June 18, 2019  
NRC-19-0039

Fermi 2 Power Plant  
NRC Docket No. 50-341  
NRC License No. NPF-43

**Subject:       Response to NRC Request for Additional Information for License Amendment  
Request to Revise Technical Specification 3.3.5.3, Reactor Pressure Vessel (RPV)  
Water Inventory Control Instrumentation**

**FIGURE A**

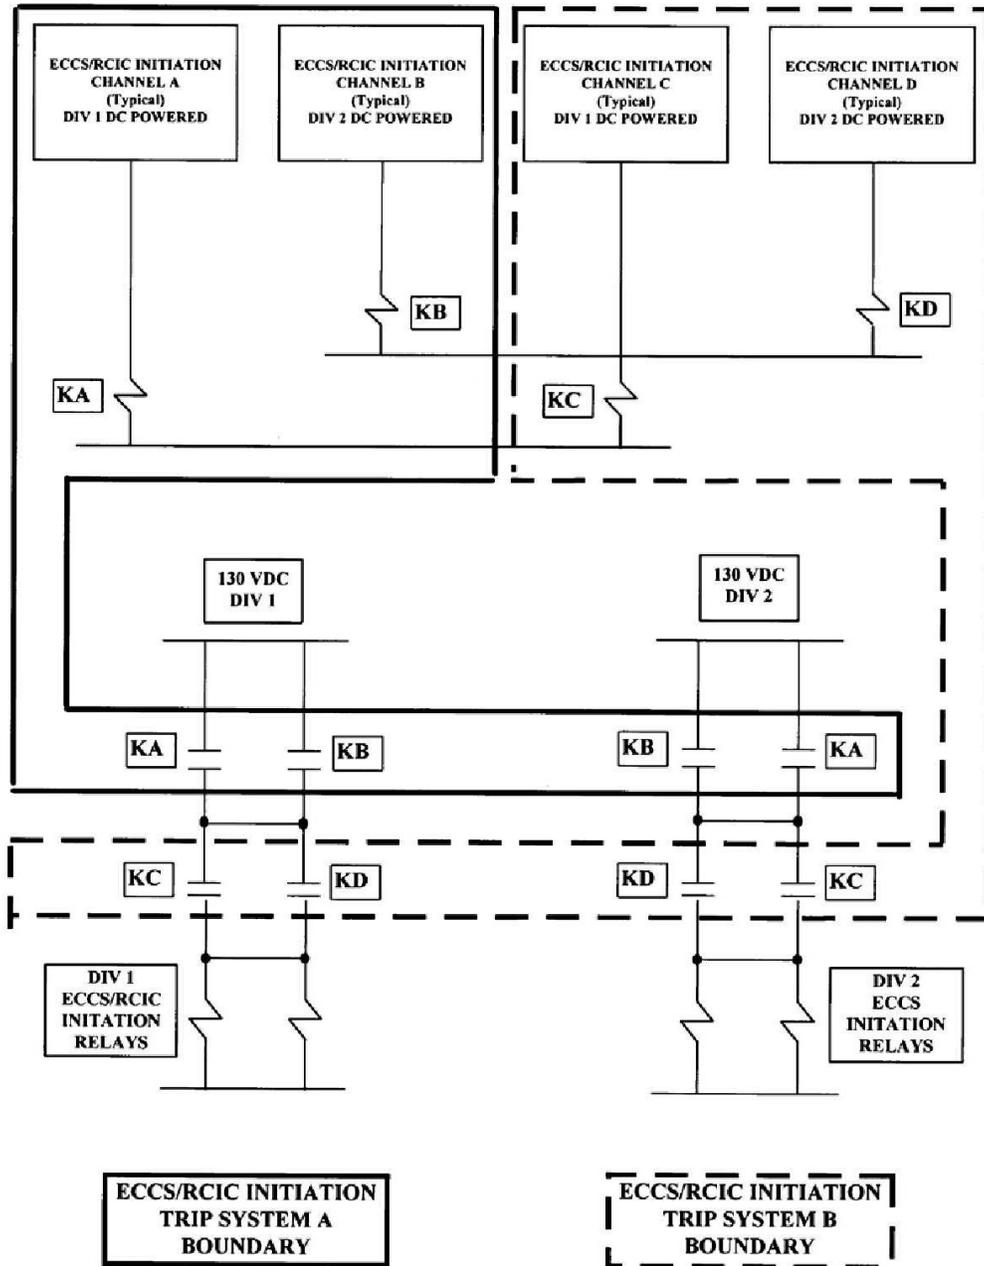
- a.) An explanation of why DTE's evaluation of proposed note is appropriate when the DRAIN TIME is shorter (i.e., less than 6 hours.) Otherwise, please consider revising the proposed note and;*
- b) a description of how the injection permissive function is maintained without placing the inoperable channel in trip as is currently required in Fermi 2 TS 3.3.5.3 Condition C (i.e., describe how the injection permission functions for low pressure coolant injection and core spray are maintained during testing.)*

Two separate reactor steam dome pressure – low (injection permissive) instrumentation channels are provided in each of the two divisions that perform the injection permissive Function for the CS and LPCI Systems. Each injection permissive channel is duplicated to both divisions of the respective low pressure ECCS subsystems actuation logics, providing a one out-of-two taken twice logic arrangement in each division. Figure A illustrates this logic arrangement generically for ECCS initiation and is representative of the reactor steam dome pressure injection permissive logic arrangement. Assuming normal power is available with no channel failure, the logic arrangement allows the two channels from one division of reactor steam dome pressure – low (injection permissive) to actuate both divisions of both low pressure ECCS systems, CS and LPCI. As a result, the injection permissive Function can be maintained with only two OPERABLE channels, provided the two OPERABLE channels are in one division. Note that injection permissive Function is assured with three total OPERABLE channels, regardless of which division the channels are in.

In this configuration, where two channels in one division are OPERABLE, the injection permissive Function is maintained to both divisions of both CS and LPCI systems. Inoperability of the other two channels in the opposite division would not prohibit the injection permissive Function. Maintaining two channels for each division and two divisions (i.e. four total channels as indicated in TS Table 3.3.5.3-1) provides capability for the CS and LPCI systems to accommodate single failures.

In the case of surveillance testing, only a single instrumentation channel is made inoperable by the test. The remaining three channels are OPERABLE, including two channels in one of the divisions. Since two channels in one division are assured to be OPERABLE, the

Function is assured to be maintained. In this testing configuration, there are certain single failures, but not all, which would prevent the Function. Therefore, the surveillance testing configuration ensures the Function is maintained, but is at a small increased risk of preventing the Function (due to single failure) relative to the configuration where all four channels are OPERABLE in accordance with TS Table 3.3.5.1-1.
